Tuesday, May 11, 2021
Medway Planning and Economic Development Board
155 Village Street
Medway, MA 02053

SALMON/WILLOWS ARCPUD FIELD CHANGE:

PUBLIC BRIEFING - BOUNDARY LANE PRELIMINARY SUBDIVISION PLAN:

MEDWAY PLACE SITE PLACE SITE PLAN:

SHEET NO. **C62**

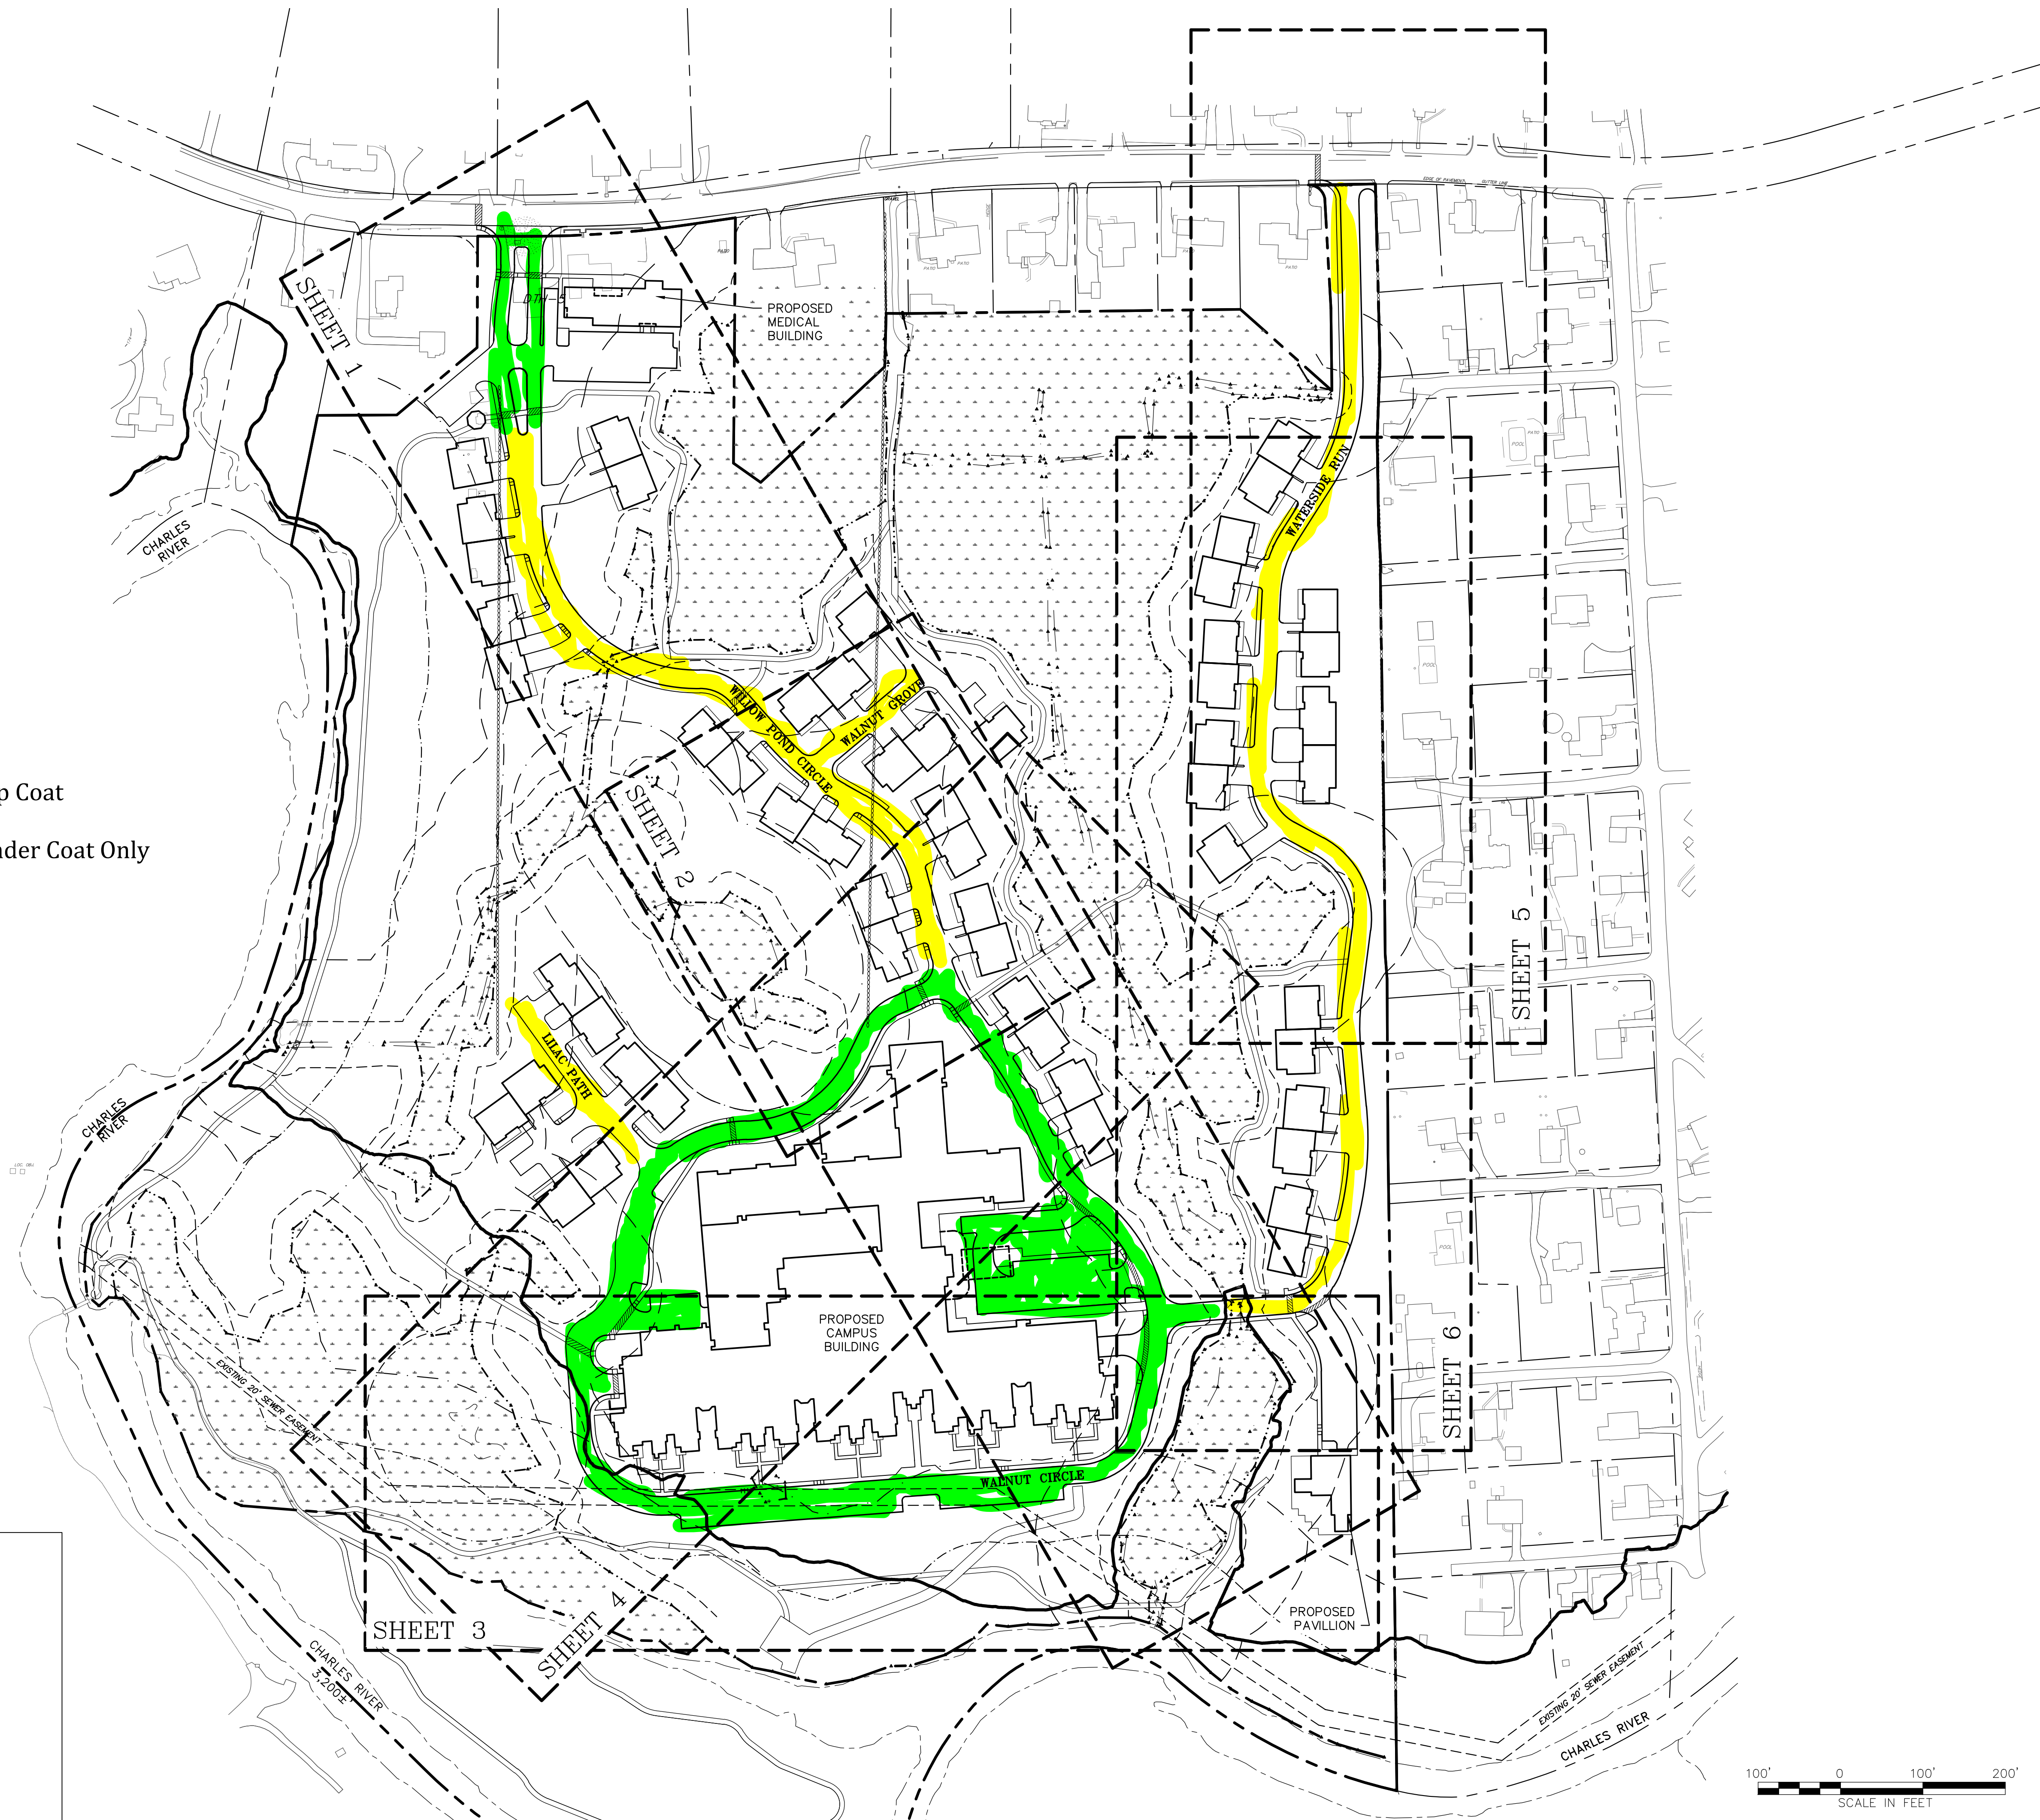
A map of the revised paving schedule was also reviewed. Mr. Robinson explained that they expect that the 305,457 s.f. main senior building containing four floors including the ground level parking and the related infrastructure will be completed on schedule. The improvements to the open space area including the trails, canoe launch, gazebo, and parking areas have been completed. The timing of the construction of the 54 cottages and the medical office building will need an extension of the completion date to December 12, 2023. This extension will be needed to complete certain infrastructure that relates directly to that portion of the project.

In accordance with Section 5 (b) and Section 32(a) of the Conditions/Limitations/Safeguards of the Special Permit, we respectfully request that the Board grant approval to the adjustments to the phasing plan and ultimate completion date to December 12, 2023.

On a motion made by Bob Tucker and seconded by Matt Hayes, the Board voted by Roll Call to approve the Field Change for the trails and also to extend the project completion date to December 12, 2023.

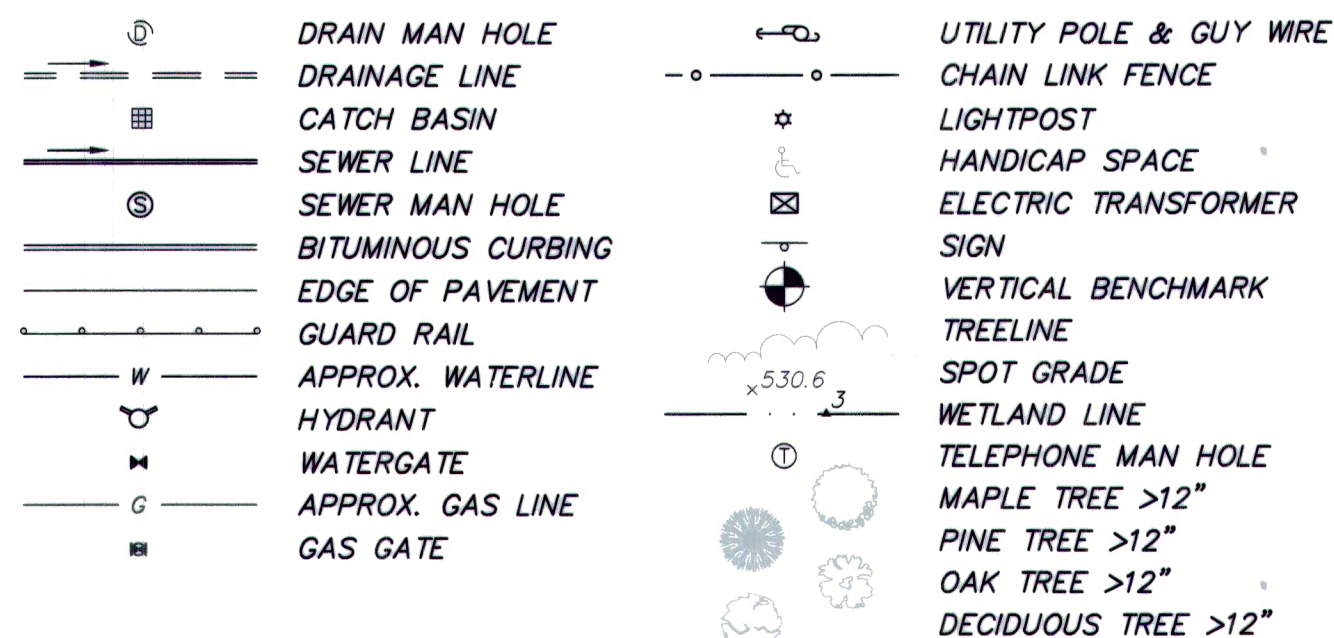
Note additional tree damage today due to root damage from road construction. Please advise of removal and replacement process.

Upon review of the photos and the Choate Trail Subdivision Plan, it does not appear that the trees Amy has noted as being damaged or removed are among those that were specified for preservation in  Choate Trail subdivision decision. The trees marked with an  were identified for removal.
